GOVERNMENT OF THE DISTRICT OF COLUMBIA
DEPARTMENT OF TRANSPORTATION

MEMORANDUM

SUBJECT: Zoning Commission Case No. 15-04 – Totten Mews

Figure 2. Site Access (Source: Applicant)

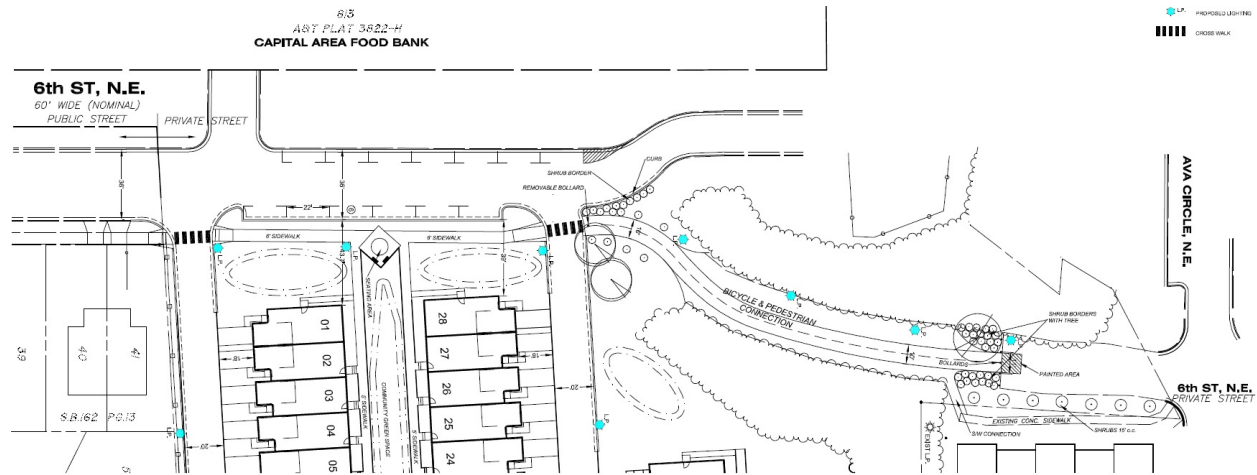
This Site is located at the end of the 4800 block of 6th Street NE, north of Buchanan Street, with a private road loop proposed around the development. The portion of 6th Street in front of the Site will remain private, however its design matches the 6th Street width to the south. The townhome residences will be accessed via the roadway loop around the Site, off of which garages will be loaded. Vehicular parking spaces are also provided on 6th Street. The proposed site access is consistent with DDOT's approach to site access.

However, the proposed development includes just the bicycle and pedestrian connection. The proposed connector does not, however, preclude a future street connection.

Pedestrians access the Site via sidewalks along 6th Street NE and the bicycle and pedestrian connector that feed into a private network of pedestrian connections within the Site. The transportation components of the local site access are shown in *Figure 2*.

Figure 4. Existing Pedestrian Infrastructure (Source: Applicant)

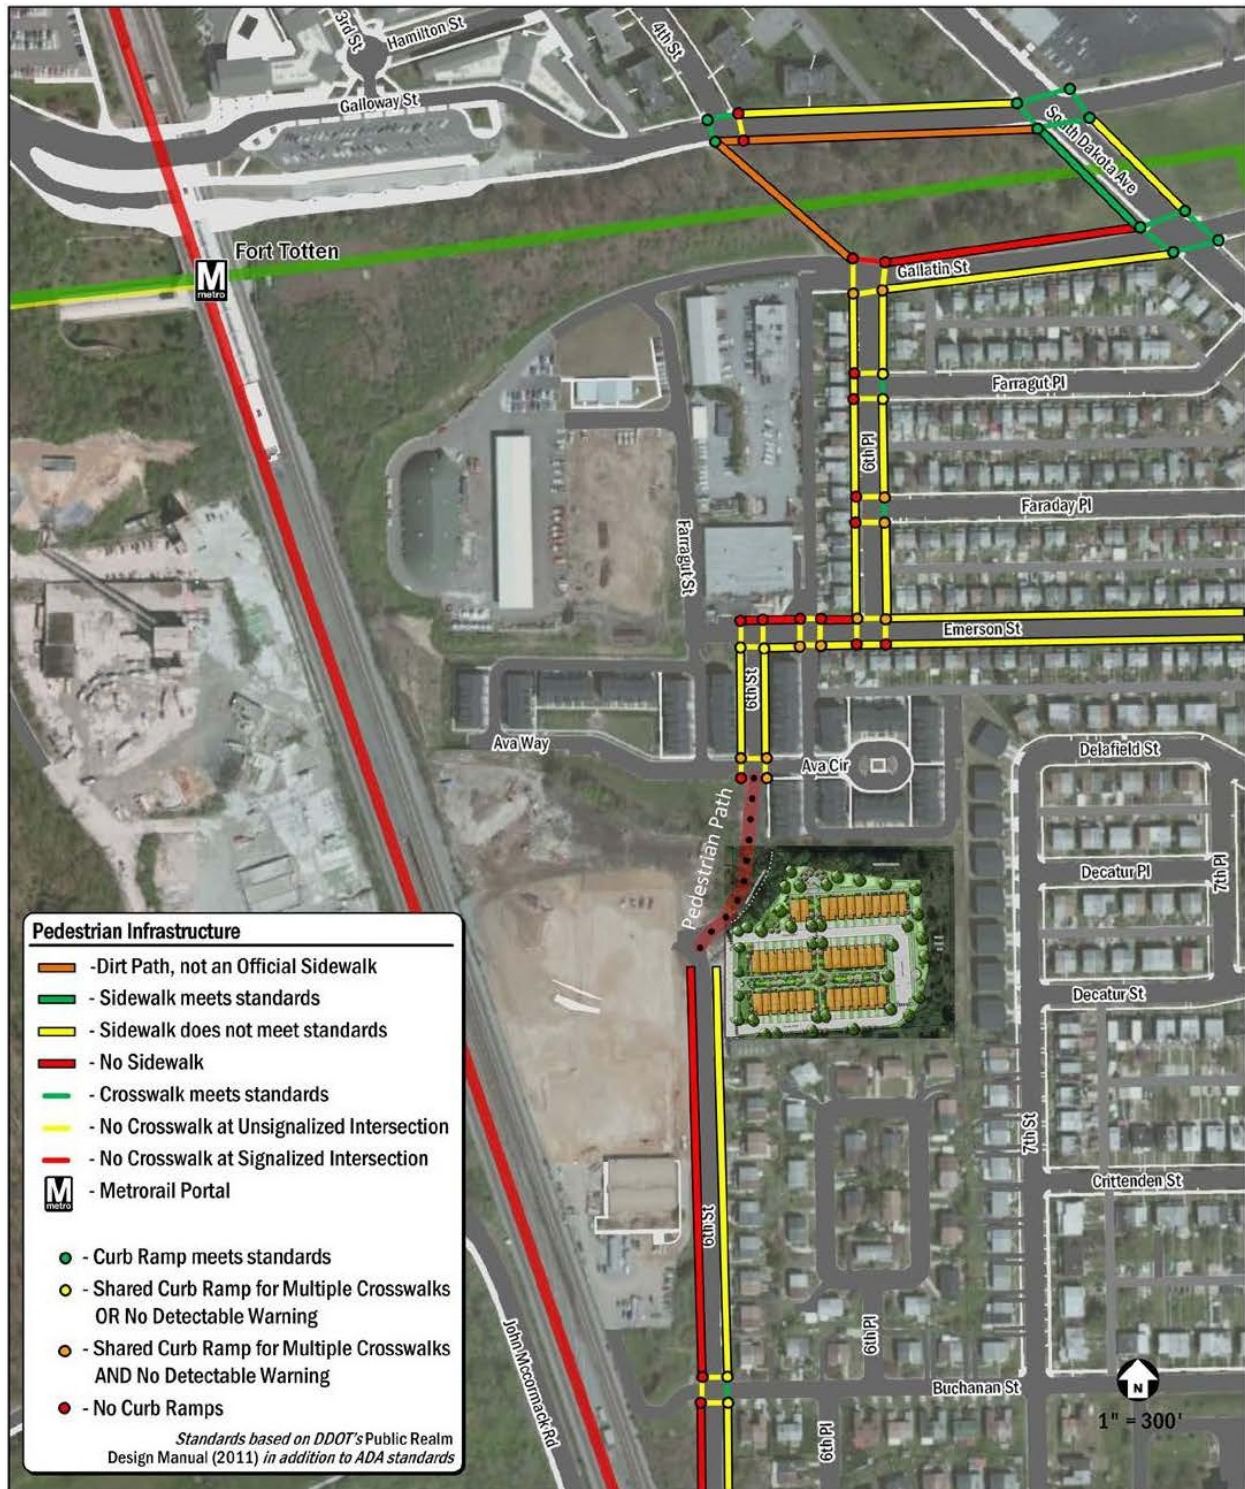
The Site has pedestrian access to nearby destinations and transit via the existing pedestrian infrastructure, with the addition of a pedestrian network proposed as part of this Site and the proposed pedestrian connector. The Applicant's analysis revealed several substandard pedestrian curb ramps, crosswalks, or sidewalks in the vicinity of the site, and they will work with DDOT to upgrade several of these locations. Deficiencies are shown in *Figure 4*. Preliminarily, upgrading of at least six sidewalk ramps, four crosswalks, and some missing sidewalk links along the path to the Metro station will be included. And these will be coordinated with DDOT as part of the public space permitting process. With these improvements, residents will be able to safely travel to and from the Metro station within the neighborhood.

- Creation of a full bicycle and pedestrian connection between the 6th Street NE links, meeting DDOT design standards; and
- Upgrading of at least six sidewalk ramps, four crosswalks, and some missing sidewalk links along the path to the Metro station, as agreed to with DDOT.

DDOT agrees with these measures and finds the proposal to be sufficient for support of the non-auto mode split of this development and to mitigate the transportation impacts seen.
